ALERT SERVICE BULLETIN
Bell Helicopter **TEXTRON**

NO. 430-05-33

SUBJECT: INTRODUCTION OF RETIREMENT LIFE FOR THE SERVO ACTUATOR TO ACTUATOR SUPPORT BOLTS P/N 50-047C8-31

HELICOPTERS AFFECTED: Model 430 helicopters serial number 49001 through 49106.

Figure 1.

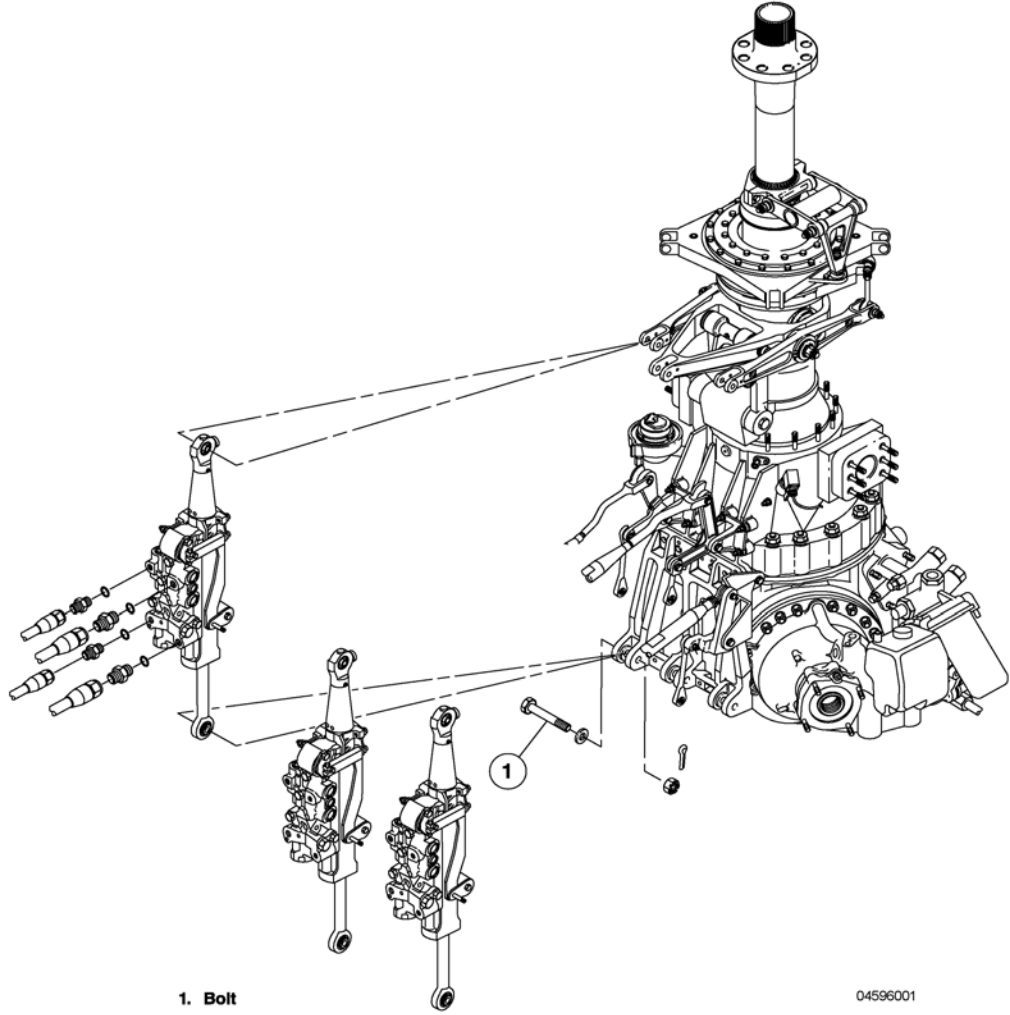
1. Remove and discard all three servo actuator to servo support bolts (Figure 1 Item 1) P/N 50-047C8-31, refer to BHT-430-MM-4 Chapter 29.
2. Install three new servo actuator to servo support bolts (Figure 1 Item 1) P/N 50-047C8-31. Refer to BHT-430- MM-4 Chapter 29.
3. Annotate the Helicopter Component Replacement record to reflect the bolts replacement.
4. Annotate the helicopters technical records to reflect compliance with this bulletin.
5. Insert the attached revised chapters 4 and 5 into the BHT-430-MM-2.
